**SUBDIVISION
PLANNED UNIT DEVELOPMENT &
REZONING
STAFF REPORT**

Emerald Oaks LLC, Subdivision

2350 Demetropolis Road
(West side of Demotropolis Road, 400'± North of
Brookfield Drive North)

Subdivision approval to create 1 legal lot of record from 3 metes and bounds parcels; Planned Unit Development approval to allow multiple buildings on a single building site; and Rezoning approval to rezone the site from R-1, Single-family Residential to R-3, Multiple-family Residential to allow a multi-family development.

SITE PLAN

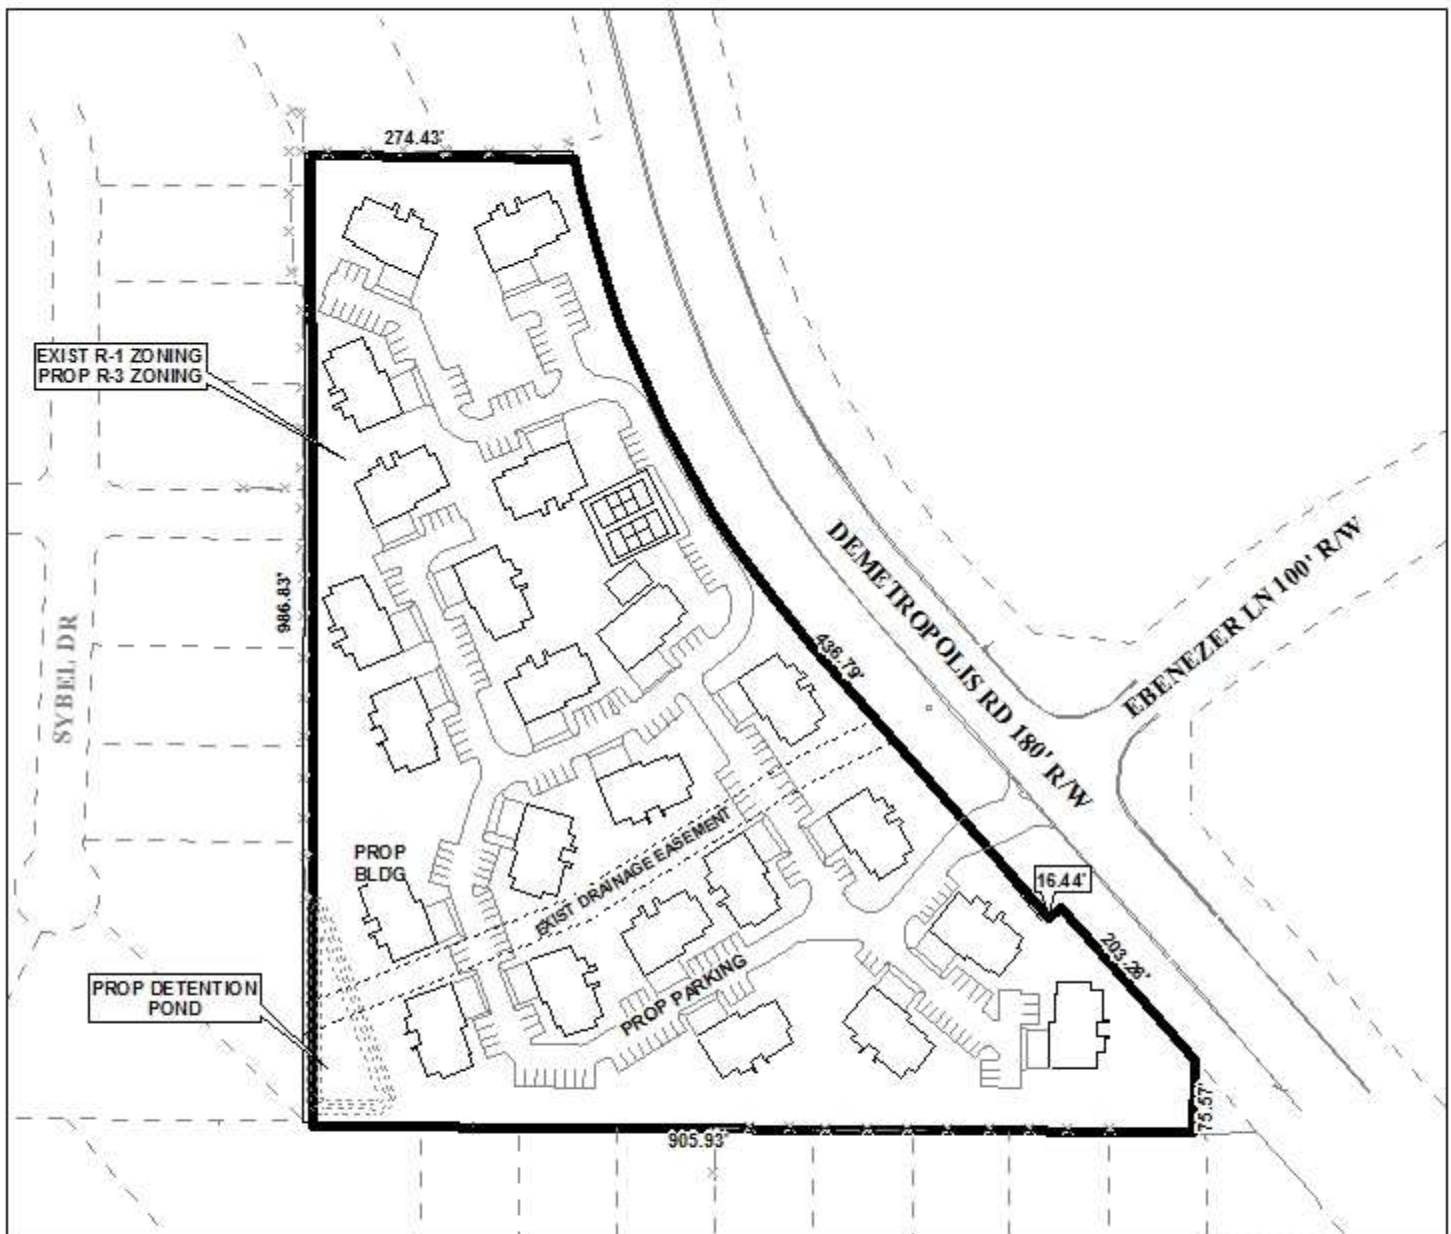
The applicant proposes multiple buildings on the site and has provided a site plan to depict the proposed site layout; however, the applicant does not provide the total number of proposed dwelling units and plan submitted does not appear to be to scale.

It should be noted that there appear to be several discrepancies on the site plan. The site plan does not indicate:

- 1) A sidewalk along Demetropolis Road;
- 2) A 10' residential buffer in compliance with Section 64-4.D. of the Zoning Ordinance;
- 3) Tree and Landscaping in compliance with Section 64-4.E. of the Zoning Ordinance;
- 4) Proposed lighting in compliance with Sections 64-4.A.2., 64-6.A.3.c., and 64-6.A.8. of the Zoning Ordinance; nor a
- 5) Dumpster pad location in compliance with Section 64-4.D.9. of the Zoning Ordinance or a note stating garbage collection will be via curb-side pick-up;

Although the site plan illustrates parking spaces and maneuverability areas, Staff could not verify if the proposed parking and maneuverability area are compliant because the applicant did not provide the total number of dwelling units nor provide a site plan to scale. Any proposed parking and maneuverability area must be in compliance with Section 64-6.A. of the Zoning Ordinance.

As mentioned previously, the site contains a large 30' ± wide drainage easement which bisects the property which is illustrated on the site plan and should be retained on any revised site plan along with a note stating that no permanent structures can be constructed in any easement.

- 1) Submittal of the total number of proposed dwelling units;
- 2) Submittal of a site plan to scale;
- 3) Revision of the site plan to illustrate a sidewalk along Demetropolis Road or the submittal of a Sidewalk Waiver request;
- 4) Revision of the site plan to illustrate and quantify full compliance with the tree and landscaping requirements of Section 64-4.E. of the Zoning Ordinance;
- 5) Revision of the site plan to depict a 10' residential buffer in compliance with Section 64-4.D. of the Zoning Ordinance where the site abuts R-1, Single-family Residential;
- 6) Revision of the site plan depicting a dumpster(s) connected to sanitary sewer as required by Section 64-4.D.9 of the Zoning Ordinance;
- 7) Revision of layout, as necessary, to reflect Engineering, Traffic Engineering and Urban Forestry comments; and
